Corridor 18-23

Yerington to Ridgecrest Corridor

Corridor Purpose and Rationale

Figure 3. Map of Conflict Areas in Vicinity of Corridor 18-23

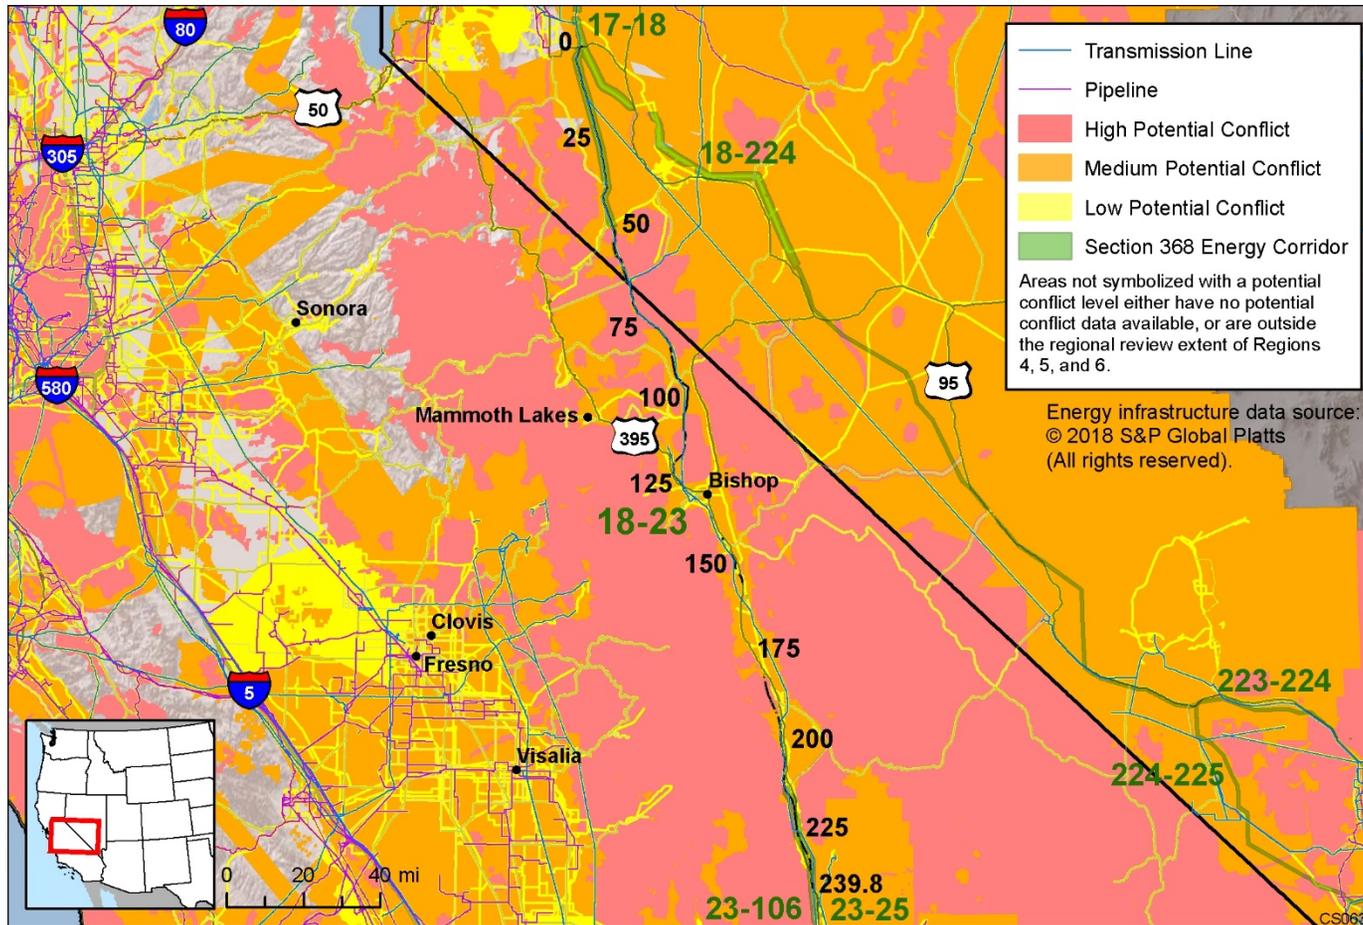
- Owens Lake MP 194 to MP 210. Object to the characterization of Owens Lake as "medium conflict" as depicted in the Conflict Map Analysis. It is known that the shoreline and body of Owens Lake is very important to local Tribes, both historically and present day. Owens Lake and the surrounding shoreline should be characterized on the Conflict Map as "high conflict." Owens Lake has been nominated by the Native American Heritage Commission to the National Register of Historic Places as an Archaeological District, Cultural Landscape and/or Traditional Cultural Property. This designation was proposed in 2017. Our understanding is that people are presently working to complete the paperwork necessary to allow the nomination to proceed (comment on abstract).
